#PLN-2023-163
**1501 Carlemont Drive – Rezoning, Preliminary PUD,
Preliminary Subdivision and SUP**
Project Review for Planning and Zoning Commission

| <u>Request:</u> | <ol style="list-style-type: none">1. Rezoning from R-2 PUD Single-Family Residential to B-2 PUD General Commercial2. Preliminary Planned Development for a four-lot commercial development and car wash3. Preliminary Plat of Subdivision4. Special Use Permit for a car wash |
| <u>Location:</u> | 1501 Carlemont Drive |

1 EXTERIOR ELEVATION - NORTH (OPTION A)
3/16"=1'-0"

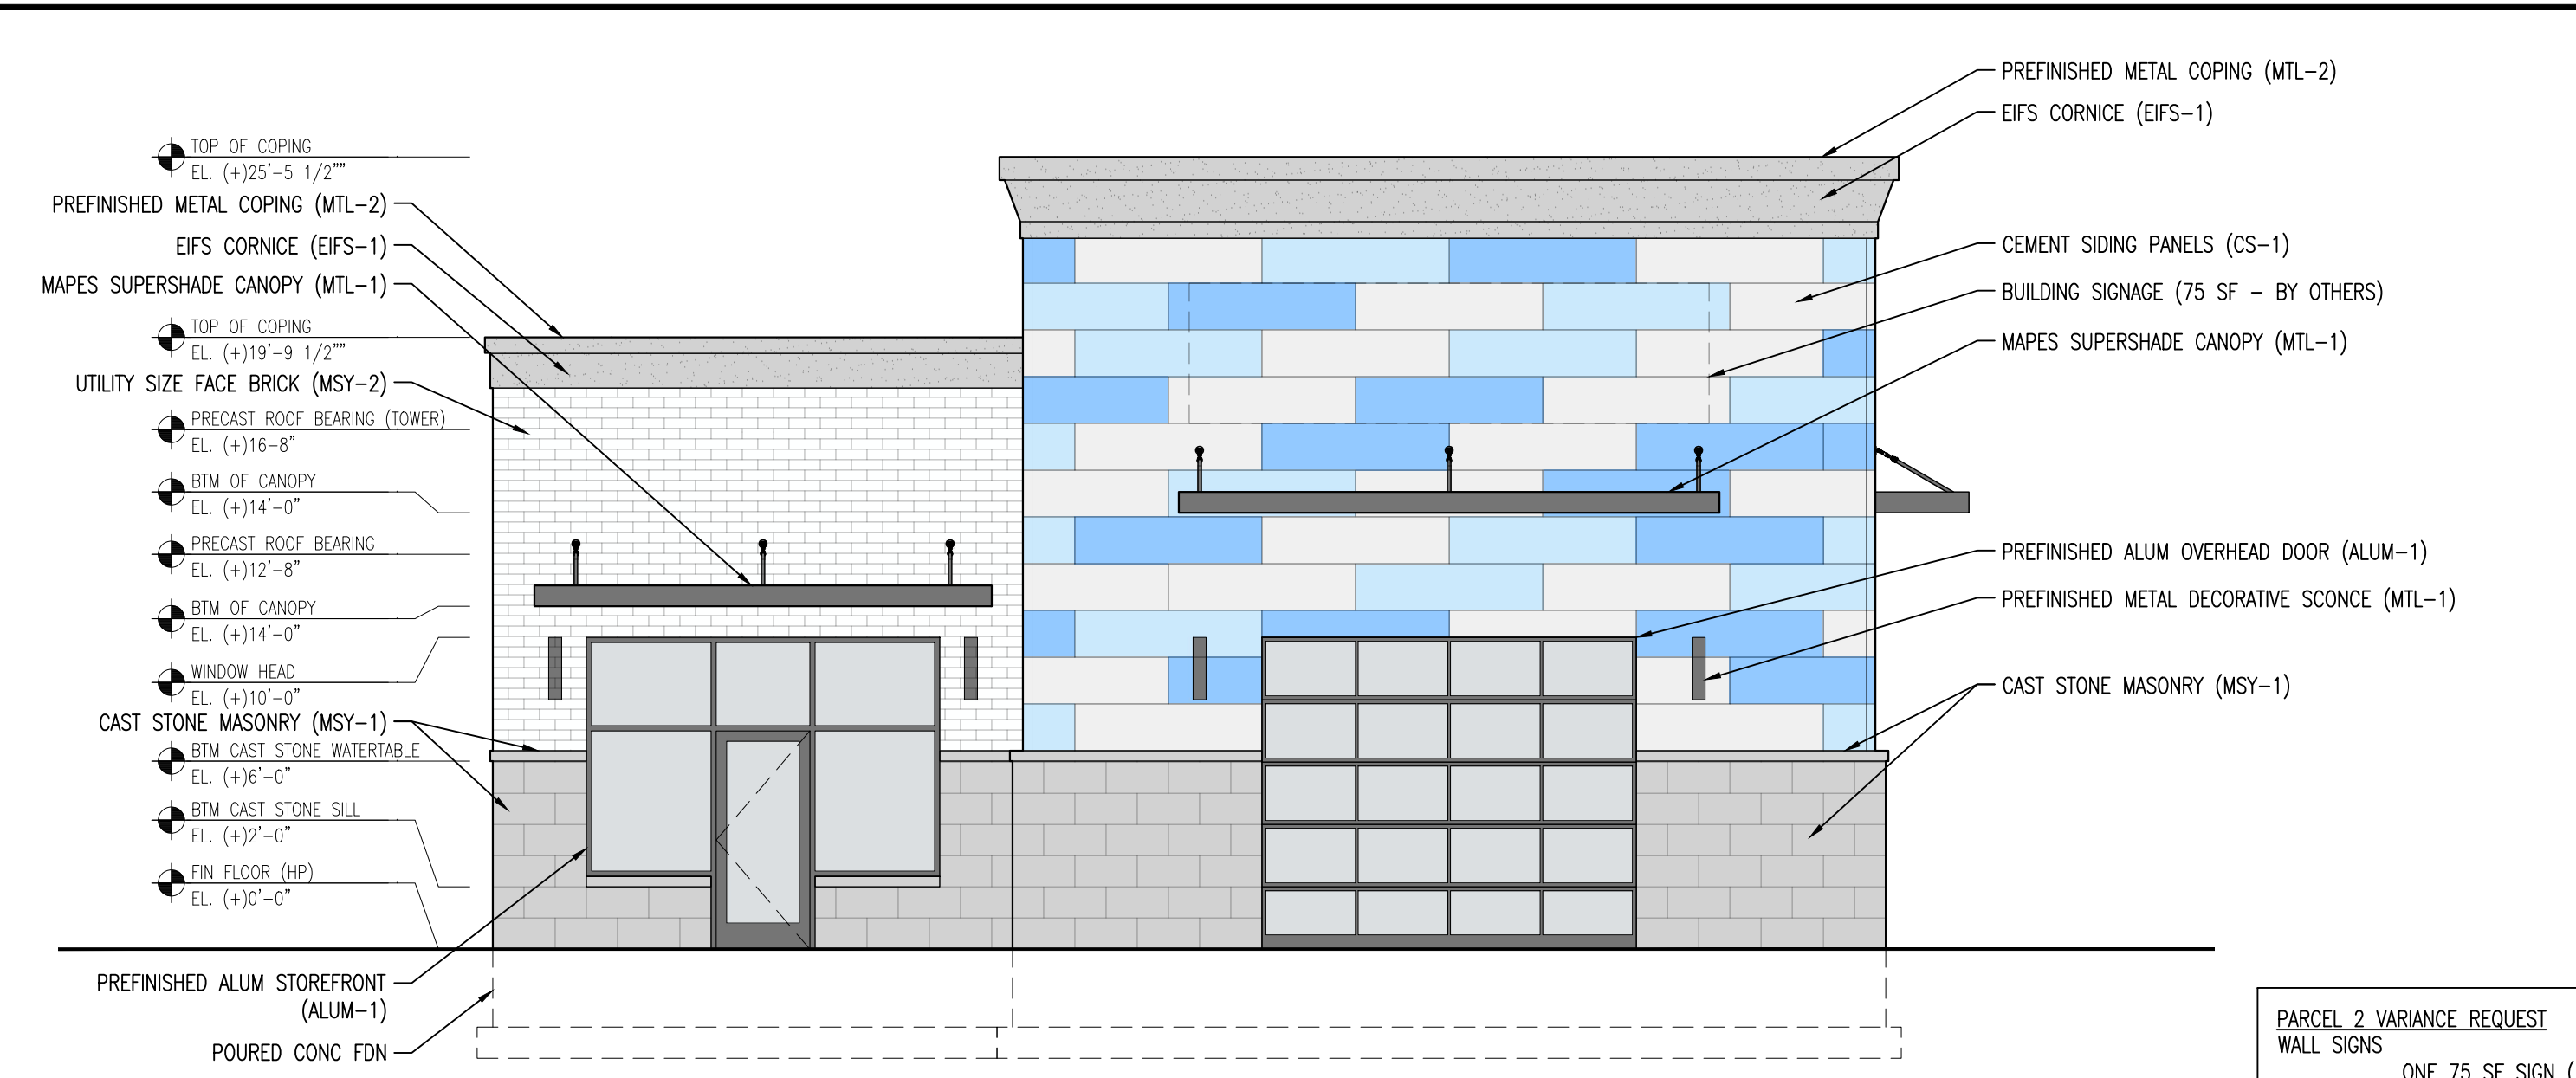
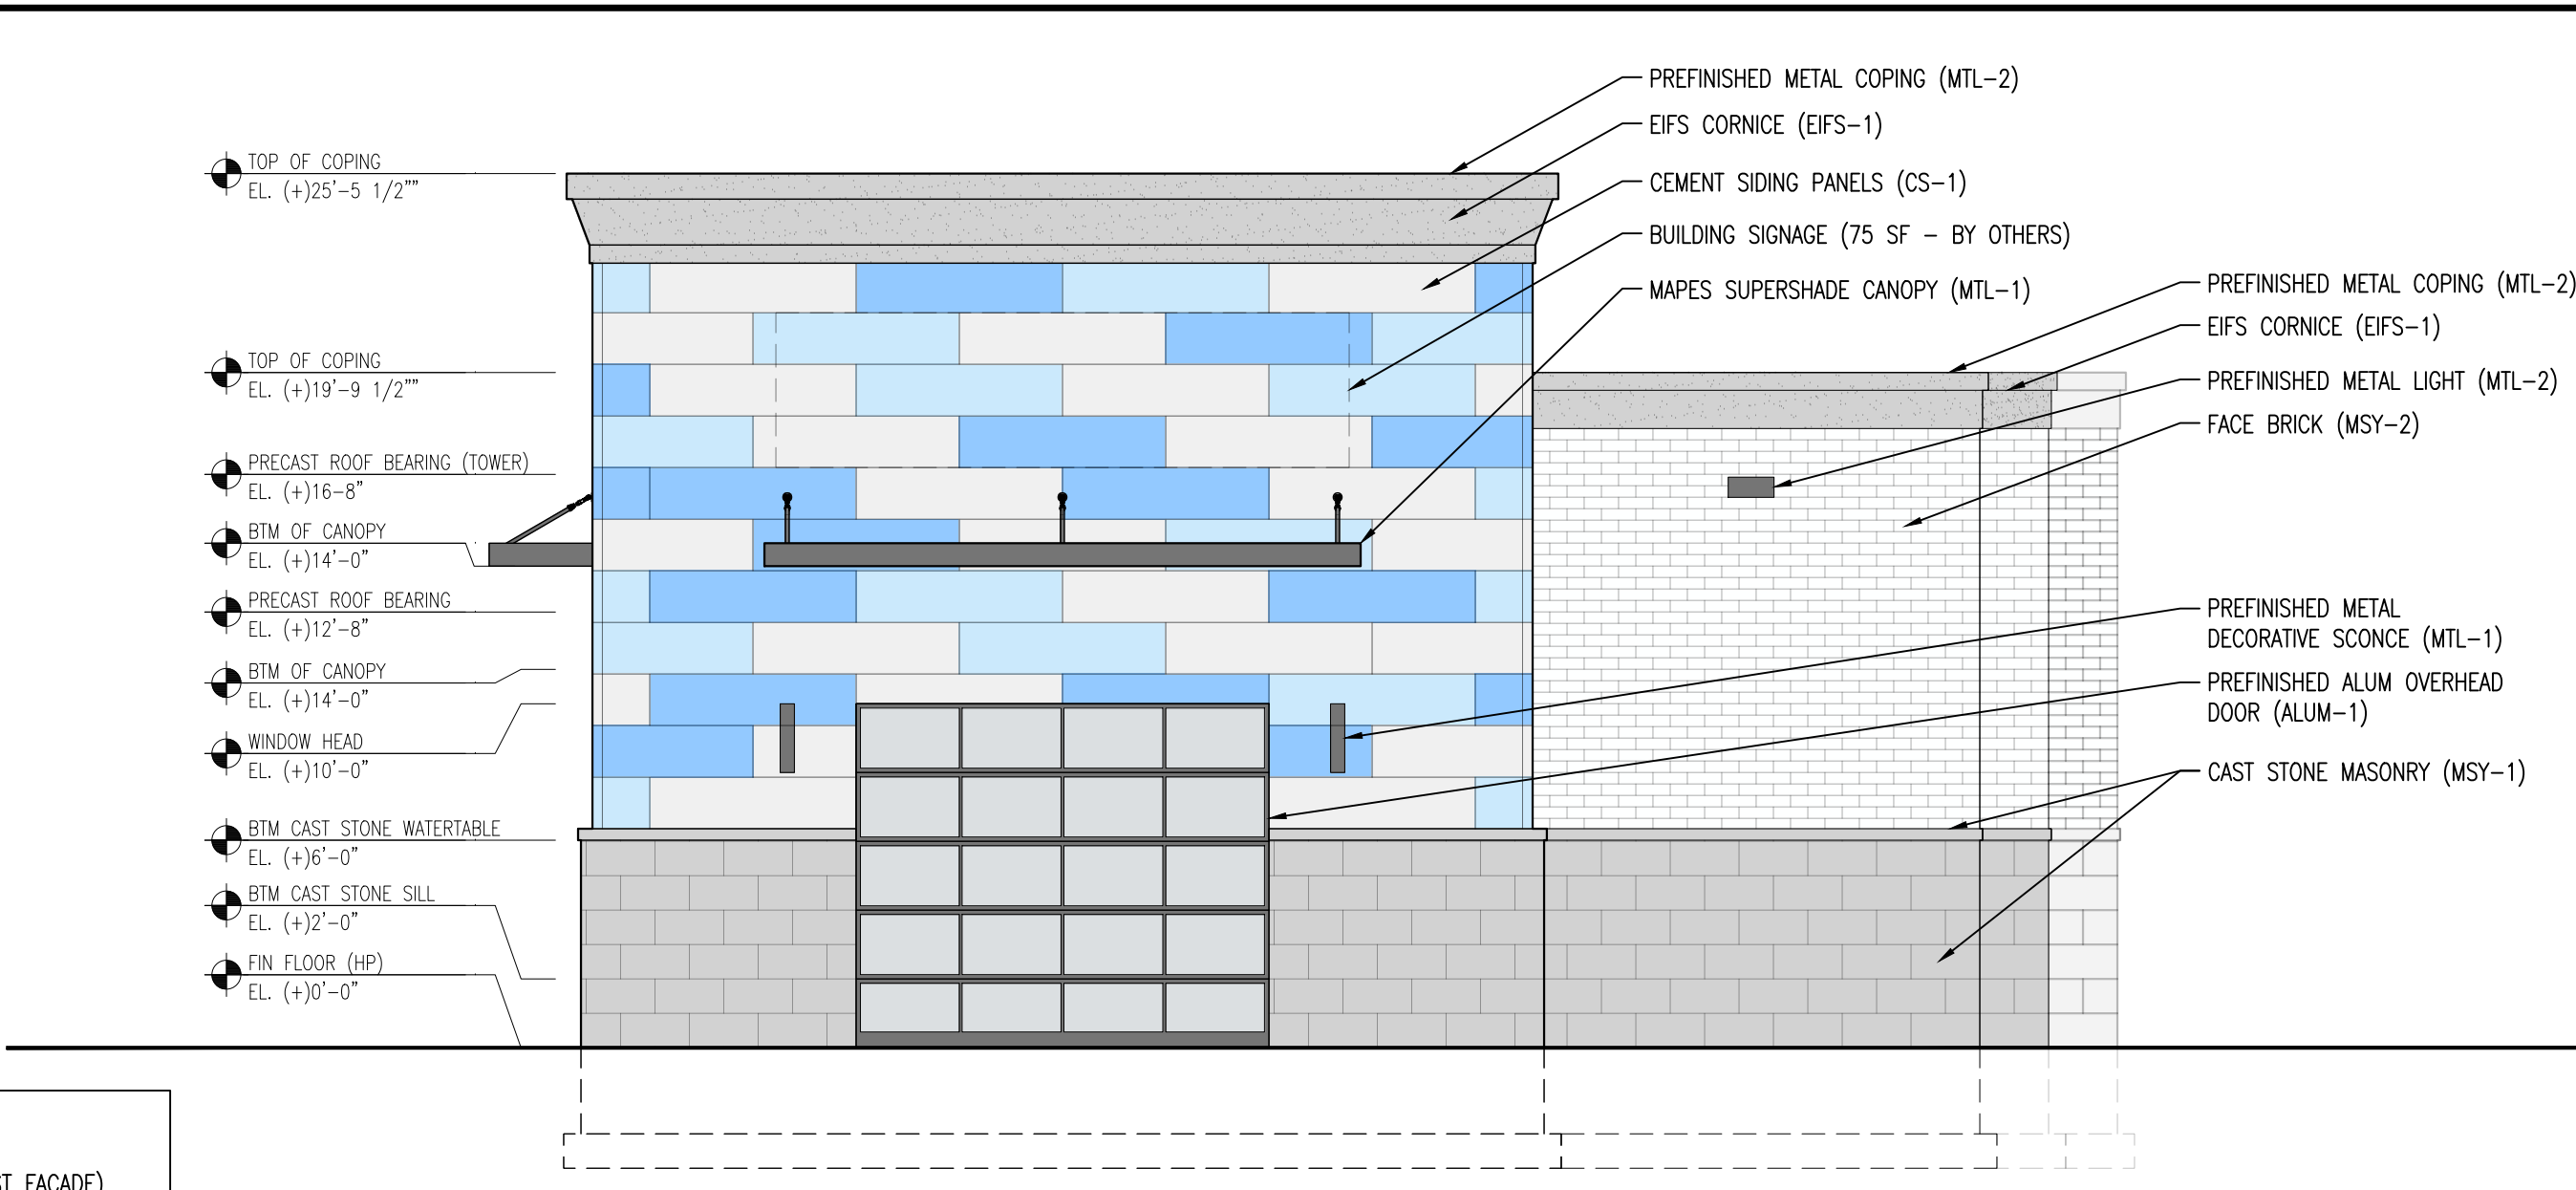
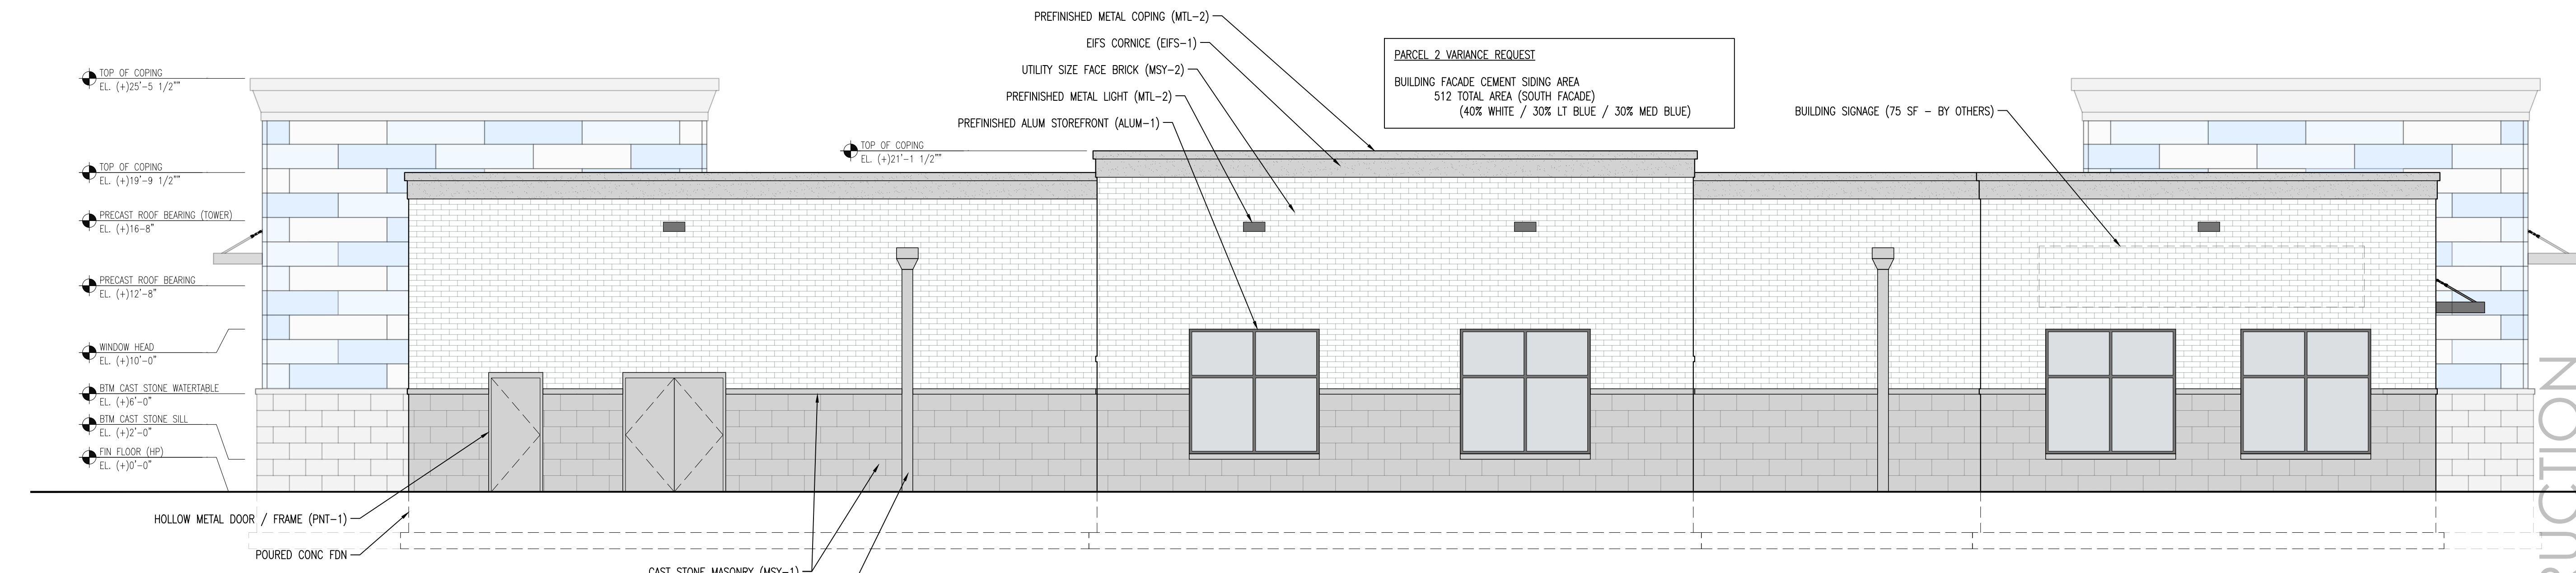
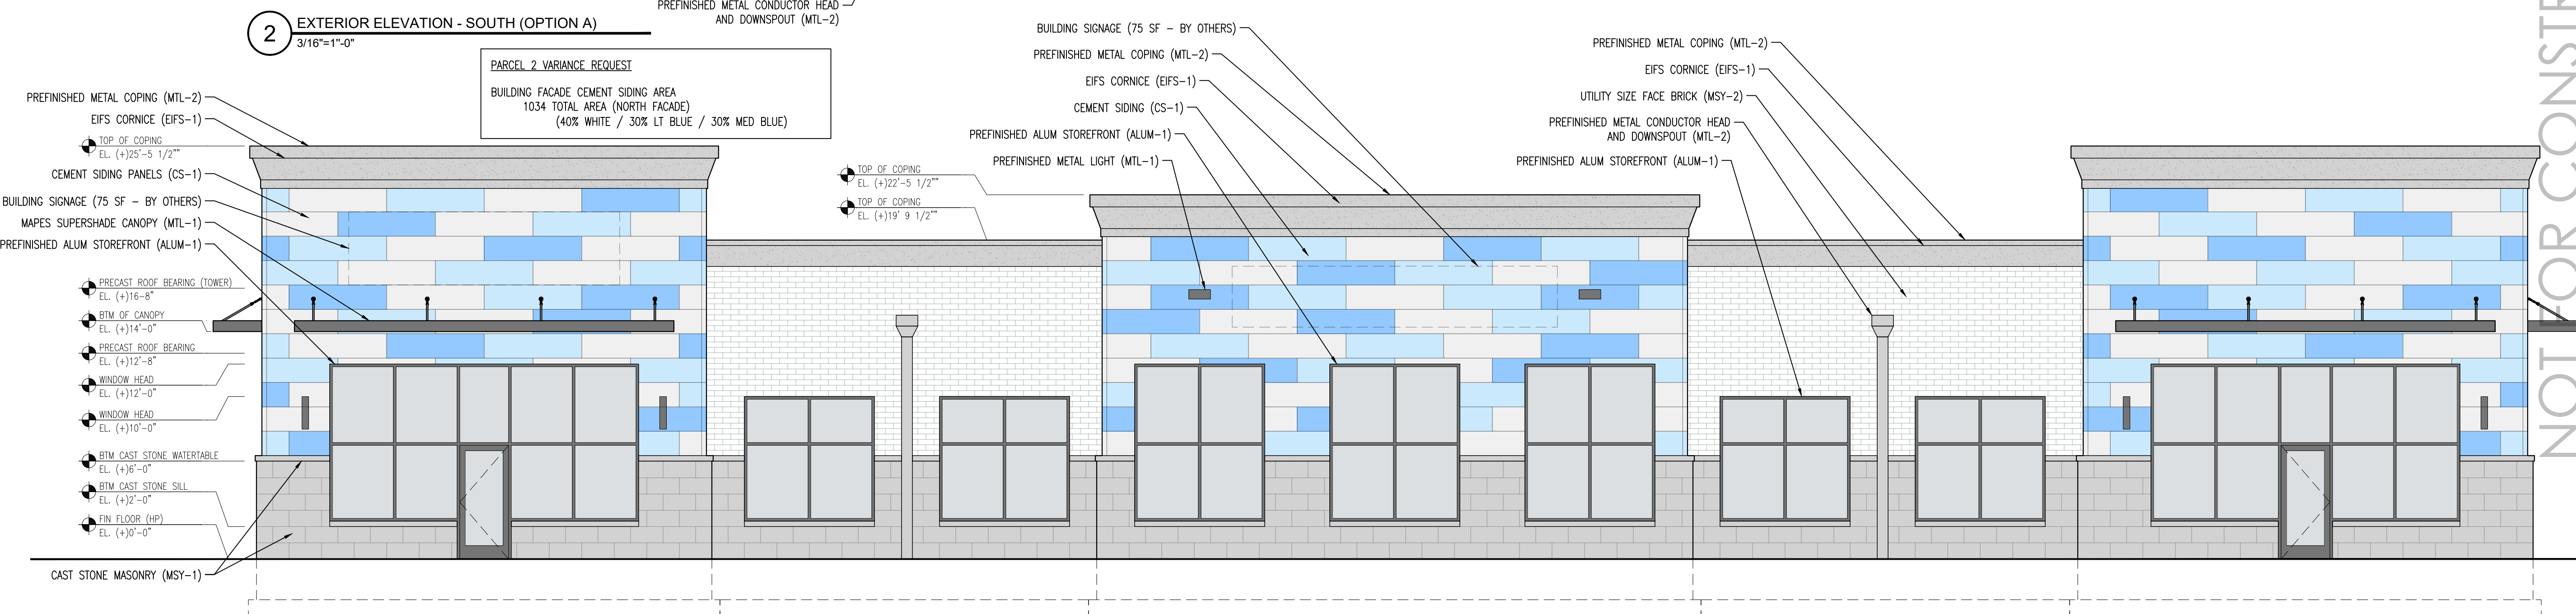
- The white and blue cement siding panels on the car wash are considered wall signage and would require a sign variation. This is similar to the requirement that Swift Car Wash had to receive a variation for painting the façade blue.
- Below is a chart of the requested colored siding area and wall signage. Staff recommends reducing the amount of colored siding.

The white and blue cement siding panels are considered wall signage and account for approximately 2,200 square feet of sign area.

4. Signage:
 - A. Final sign plans must be submitted.
 - B. No wall mounted lighting or ground mounted lighting shall be installed to illuminate sections of the wall to further create the appearance of signage.
